ATTACHMENT F

Stakeholder Outreach and Responses

South Ripley Solar Project

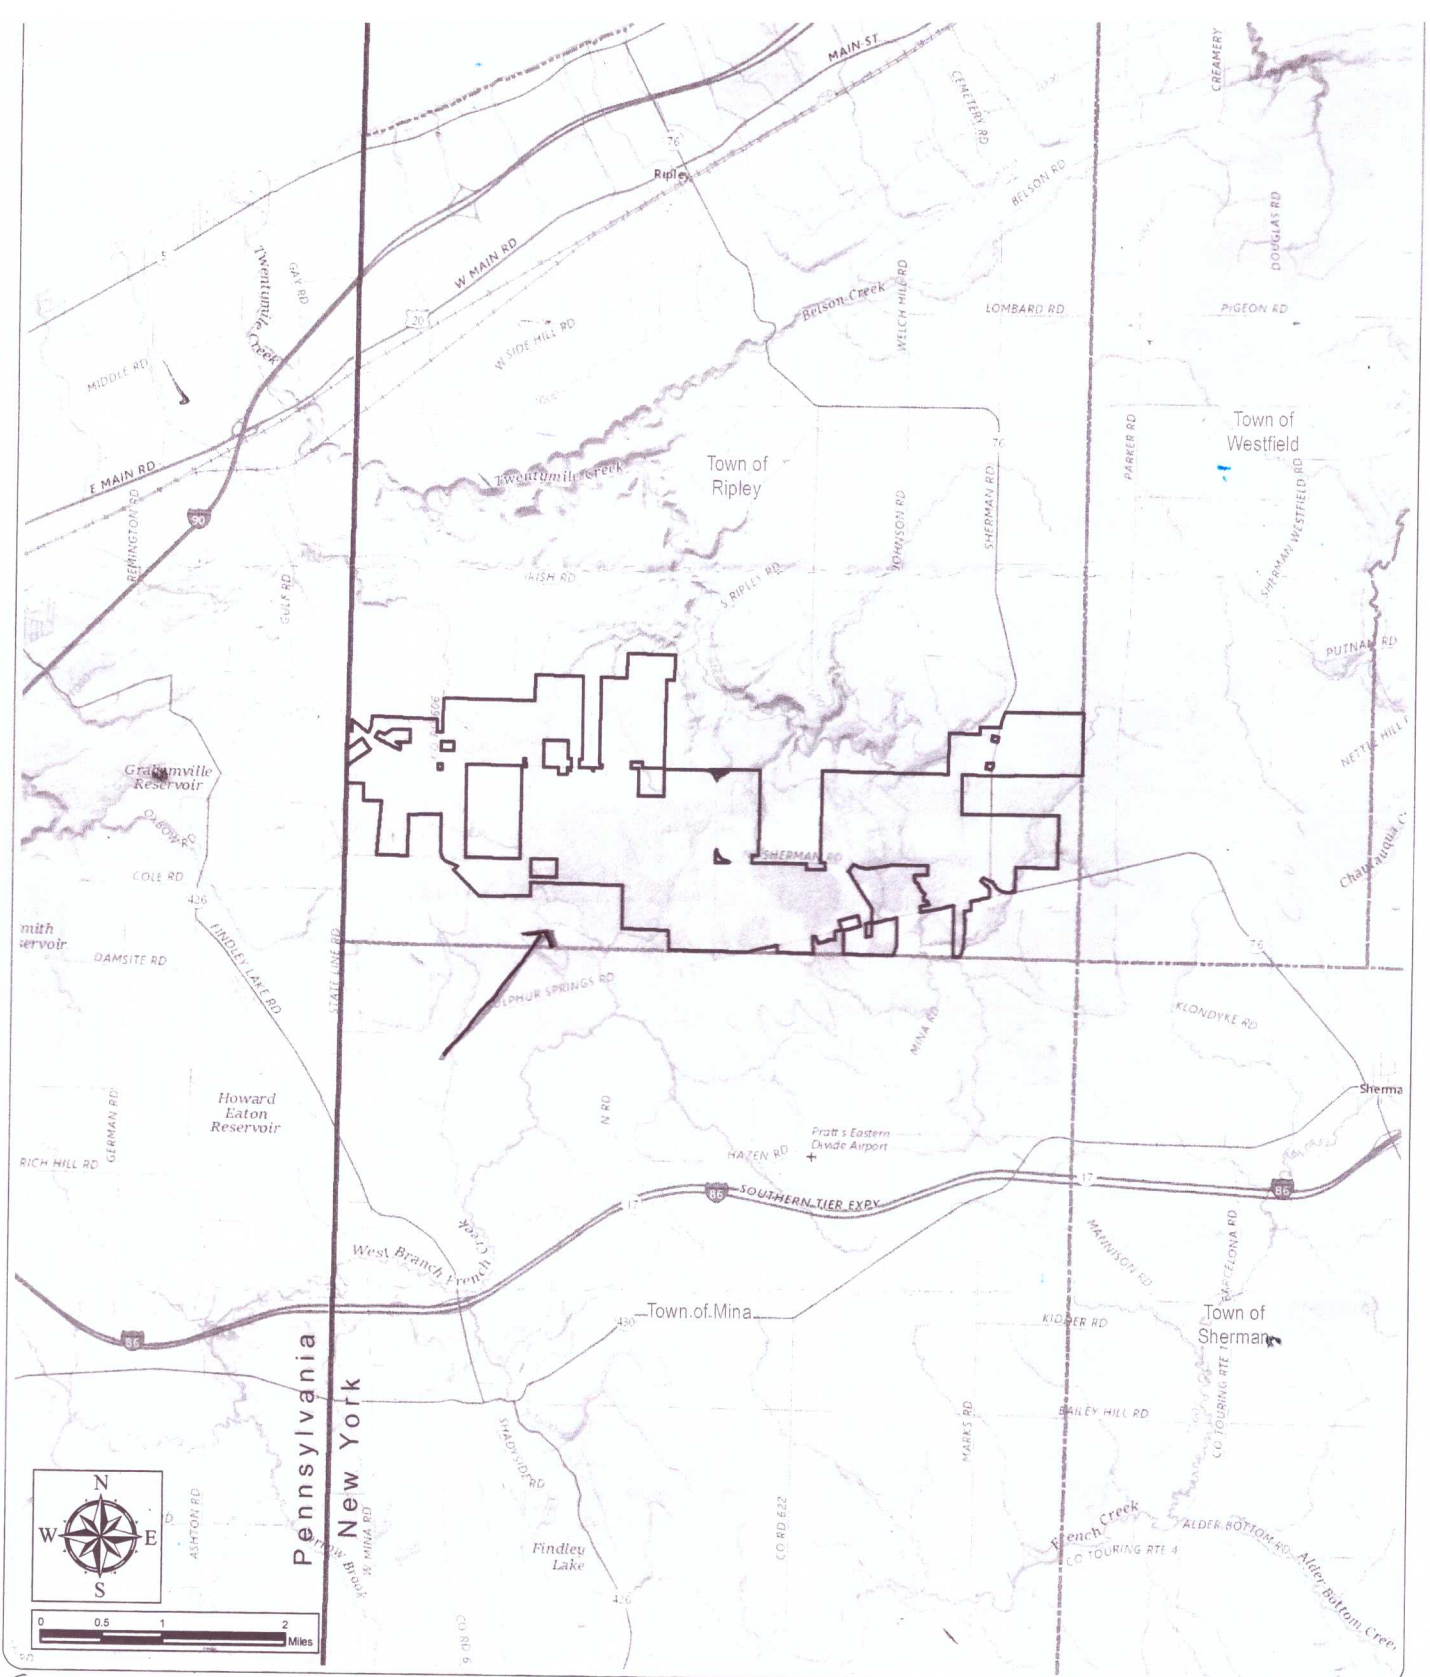
I have attached a copy of a note and map a community member left on my desk. It is hard to see on the attached map but the arrow is pointing to a large pond. I think it would be a good idea to list such a large pond as a Visually Sensitive Resource. The front half of the pond is situated on 142 acre hunting camp owned by Hound Dog Rod and Gun Club out of the Buffalo area. The back half of the pond has been in the Purdue family for several generations. If you have any questions please let me know.

I reviewed the documentation from Environmental Design + Research requesting any notes on visual sensitive places within the area of the Solar Project in South Nisley.

After looking at the map, there is a rather large water body just south west of the project off of North Road + Sulphur Springs. It's not listed in the report + it is unnamed on maps that I checked. Should this be listed with "Lakes, Ponds + Reservoirs"?

I've indicated it with an arrow on attached map.

Response: The unnamed pond was added to the VSR analysis.
